Southwest Coastal Design Review / Citizen Advisory Committee Regular Meeting

STAFF REPORT

Request: Convert a garage to an accessory dwelling unit, construct a garden shed and add a deck to the primary residence. Requires Major Design Review, per Land and Water Development and Use Ordinance #80-14, Section 4.102 (2)

SCHIFFMAN RESIDENCE 32016 E. SHINGLE MILL LN., ARCH CAPE.
RE-MODEL, CONVERTING EXISTING GARAGE/STORAGE TO A.D.U. AND
ADDING WOOD DECK ALONG WEST SIDE OF MAIN DWELLING.

TOTAL VOLUME AND PROFILE OF
PROPOSED STRUCTURE

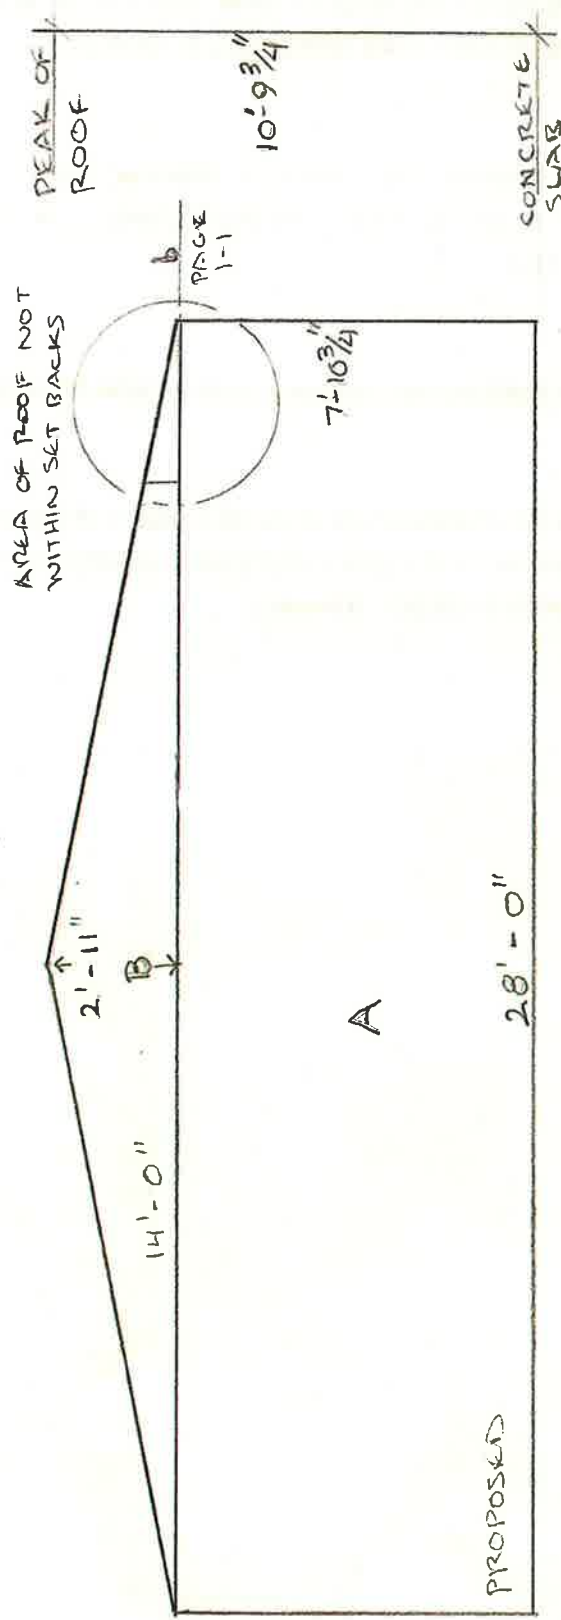
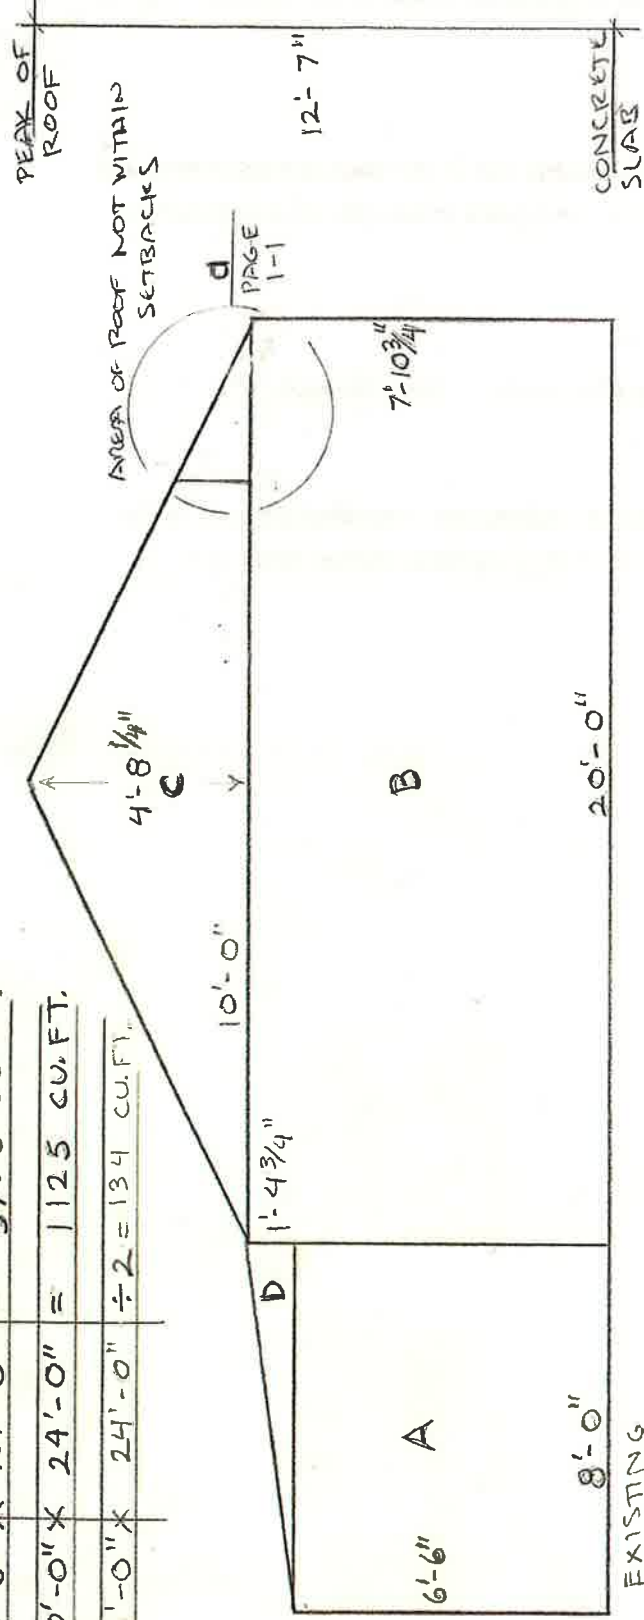
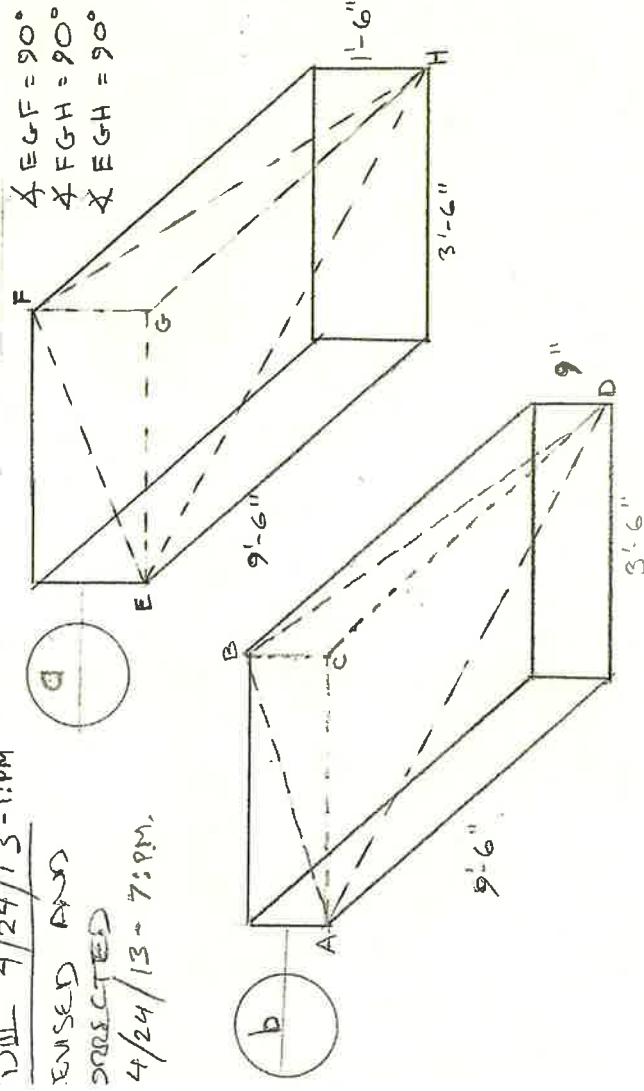
The application for conversion of the garage demonstrates the conversion would occur within the current footprint of the garage. The roofline would be changed, moving four feet southward to be centered over the entire structure; however, the peak would be lowered, resulting in a net loss of height and a reduction of volume. The change in roofline, which is necessary to adjust the south wall height to make habitable living space in the area of the current lean-to, would not increase the dimensions (height, width or length) of the structure and the volume enclosed by the structure would be decreased marginally.

WEST ELEVATION MAIN DWELLING.

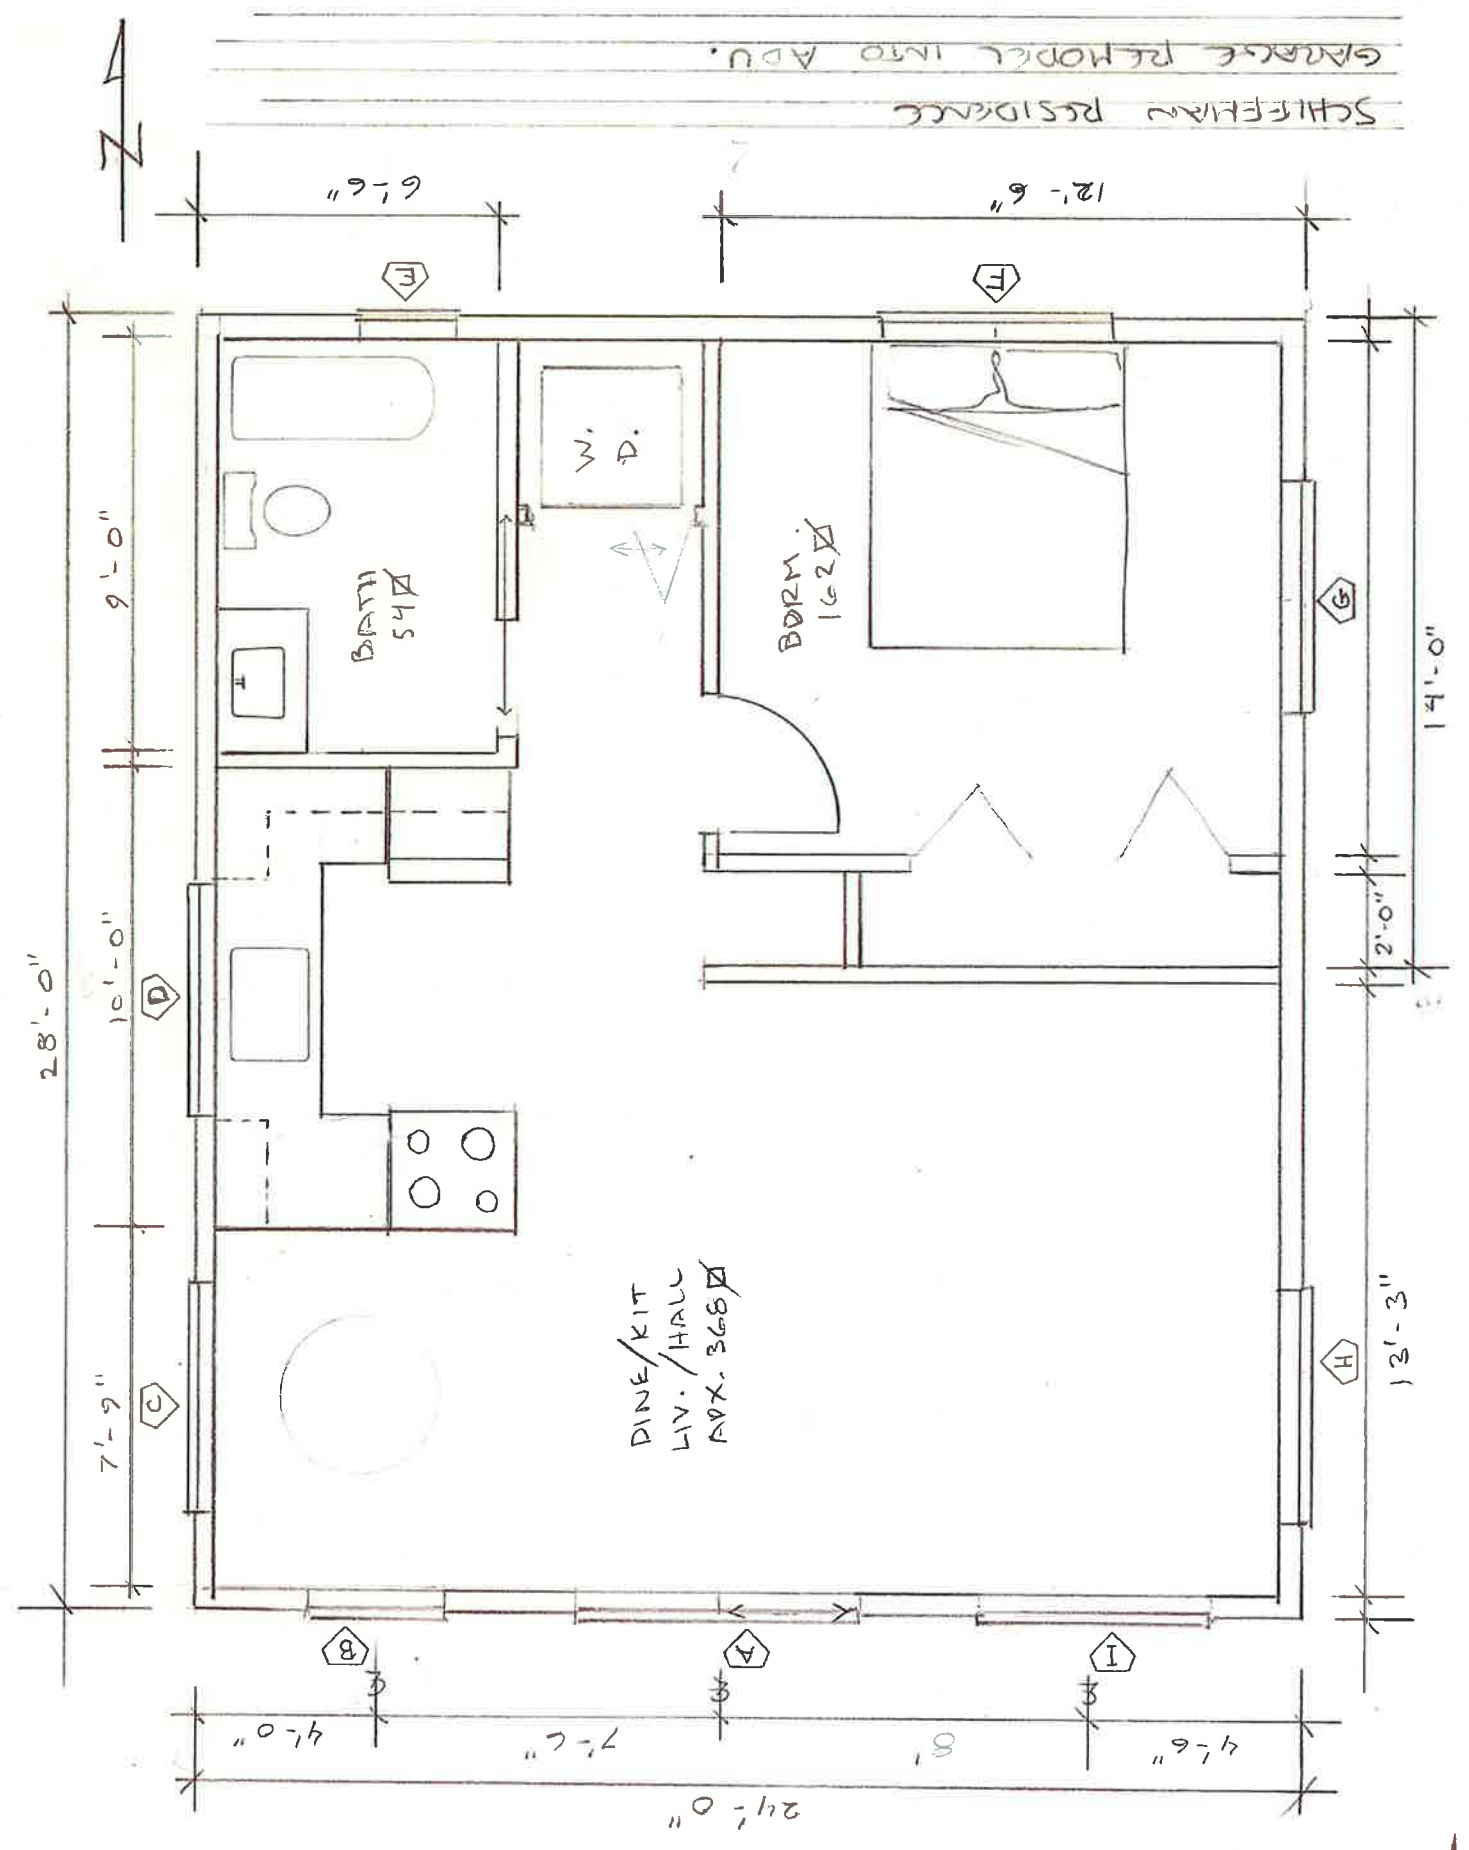
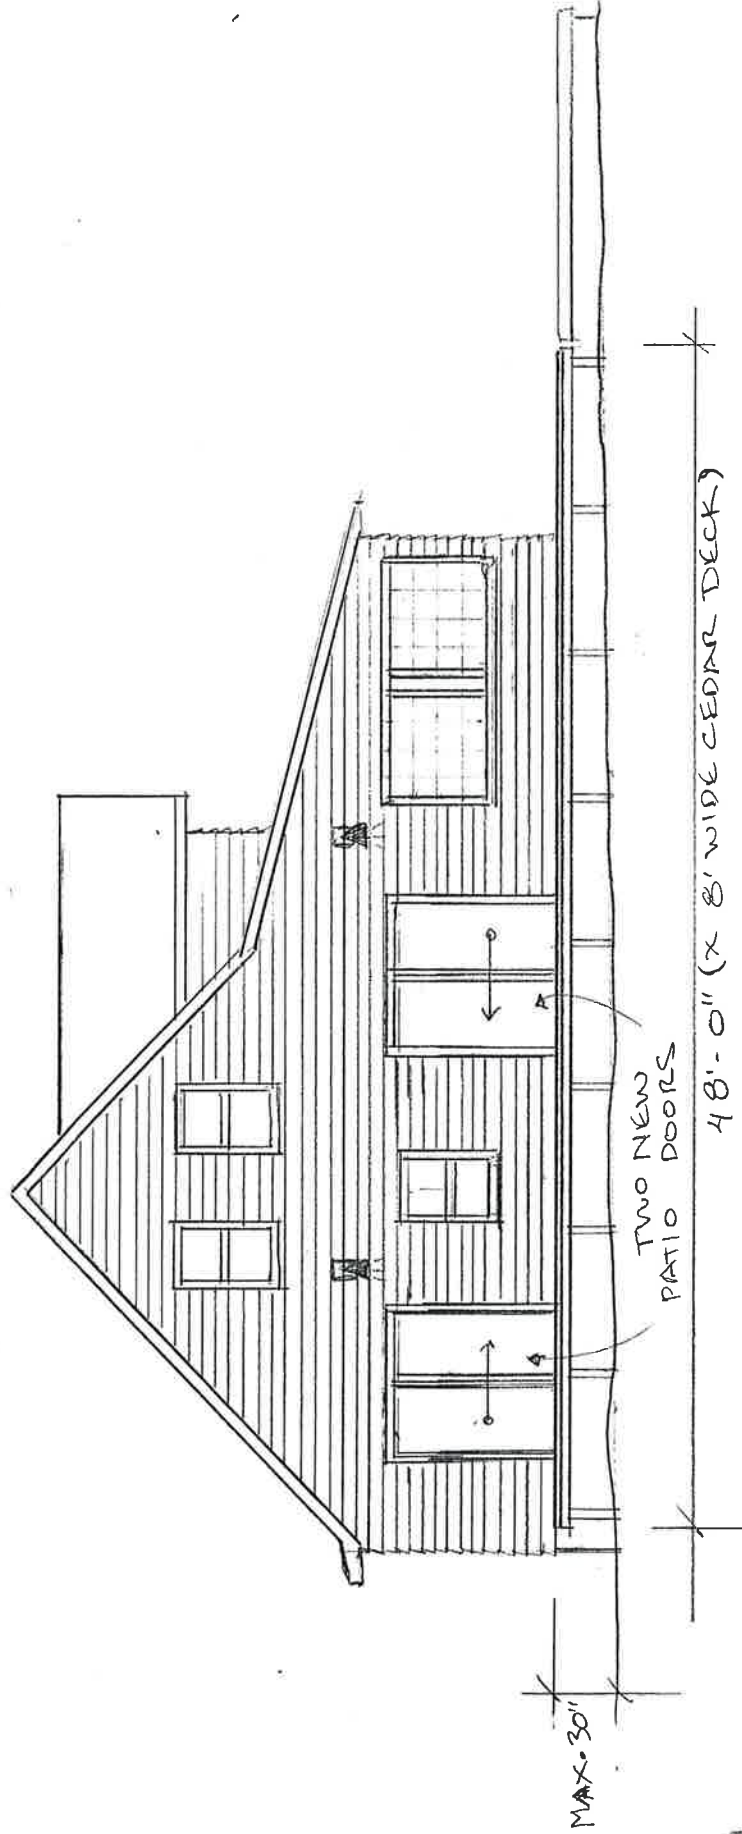
STAFF FINDING: The amount of lot coverage will increase about 5.8%, due mostly to the new deck/patio addition, through which rainwater can pass to the grass below and be absorbed as it always has. The new garden/storage shed would be guttered and the water conveyed appropriately to a green swale. The garage conversion would not change the lot coverage or increase impermeable ground cover.

Should the area under the new deck/patio require it, additional, low-growing ground cover appropriate to a semi-shaded environment could be planted to assist with water absorption; however, the no increased accumulation of water seems likely. A condition of approval will be recommended that the garage conversion be guttered, like the new shed, and tied into the existing drainage system.

8. Water drainage for the garage conversion's roof shall be directed to the existing drainage system via gutters or other appropriate means, and the drainage plan shall be included on building permit drawings.

NORTH ELEVATION - GARDEN/STORAGE SHED

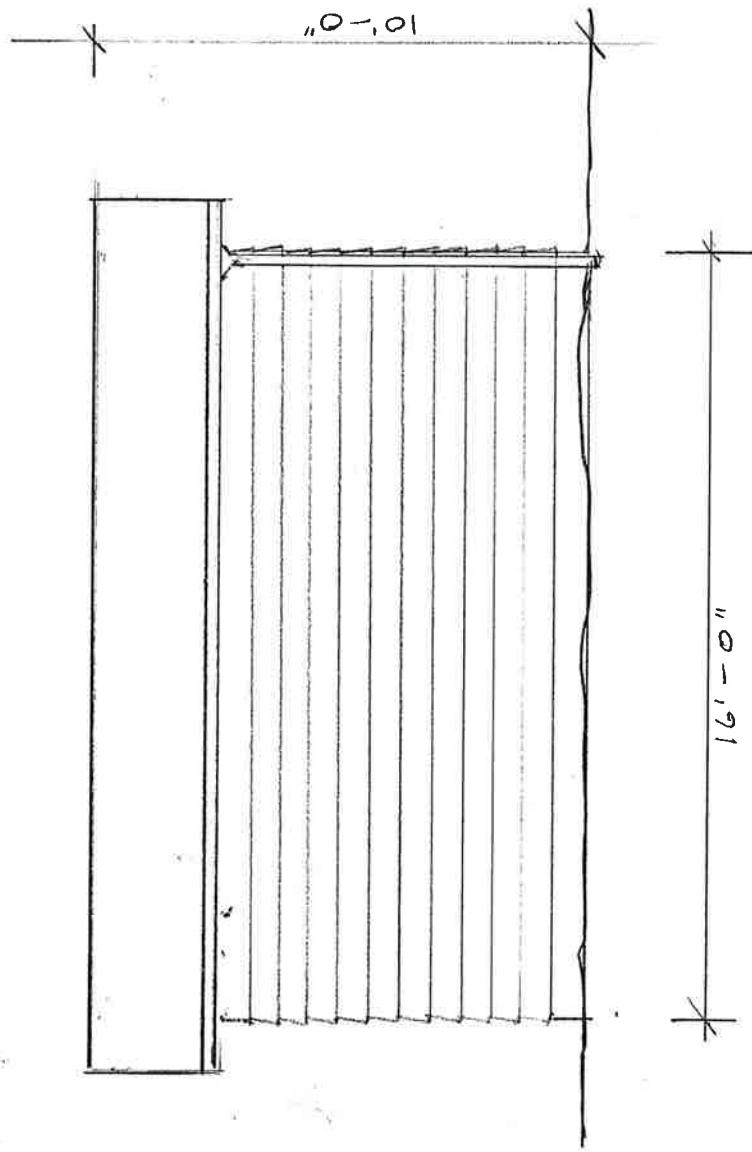
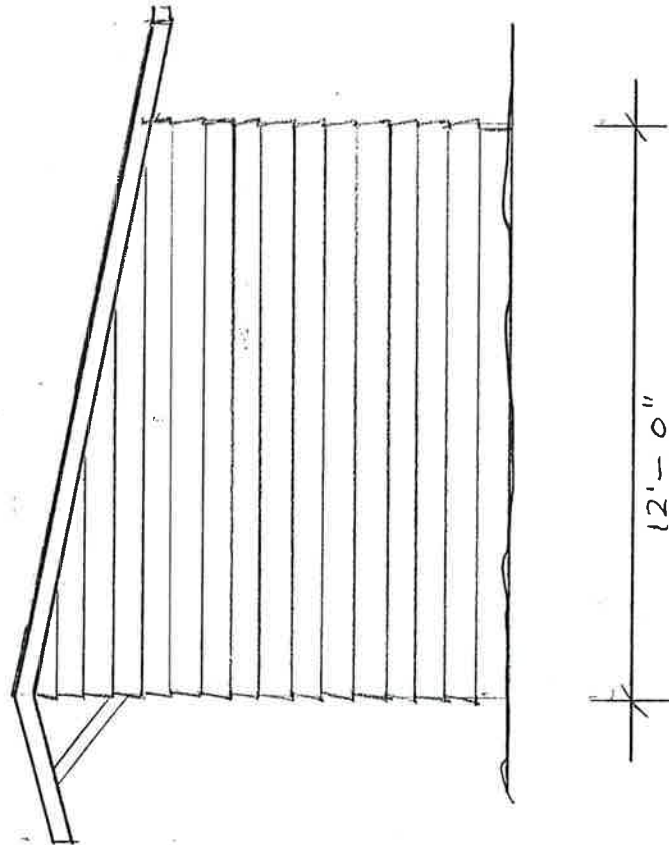
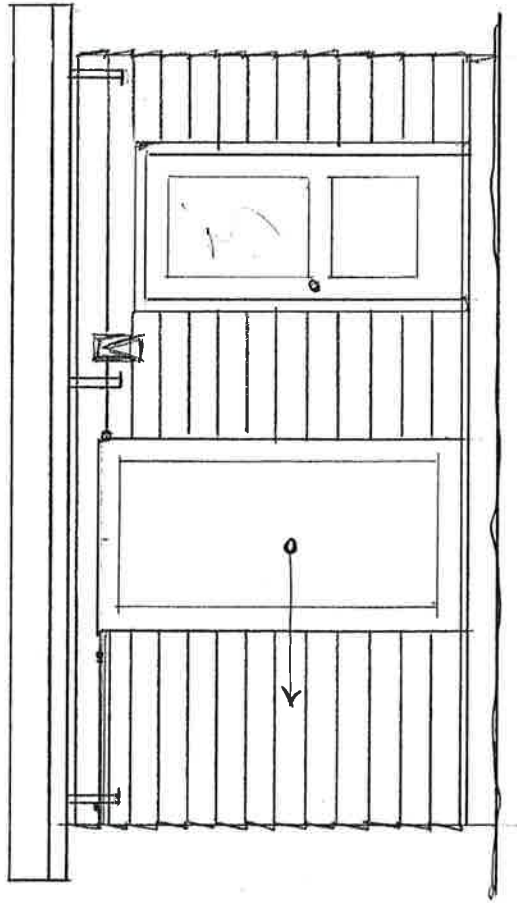
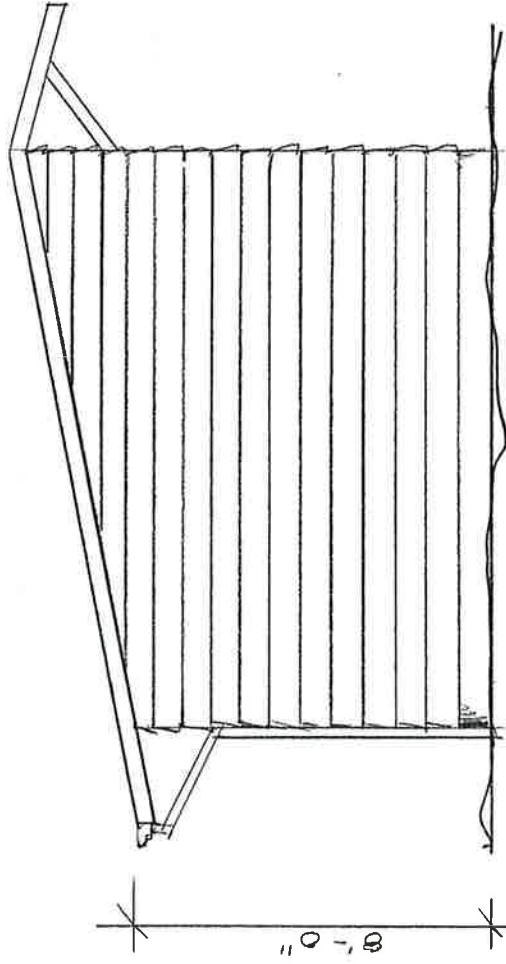
Amber M. Johnson, Oregon Department of Fish and Wildlife Habitat Conservation Biologist, provided comment, stating the new garden/storage shed should be located outside the riparian setback for Arch Cape Creek.

STAFF RESPONSE: The new shed will not be located within the riparian setback. Staff contacted Ms. Johnson, who stated she had no other concerns.
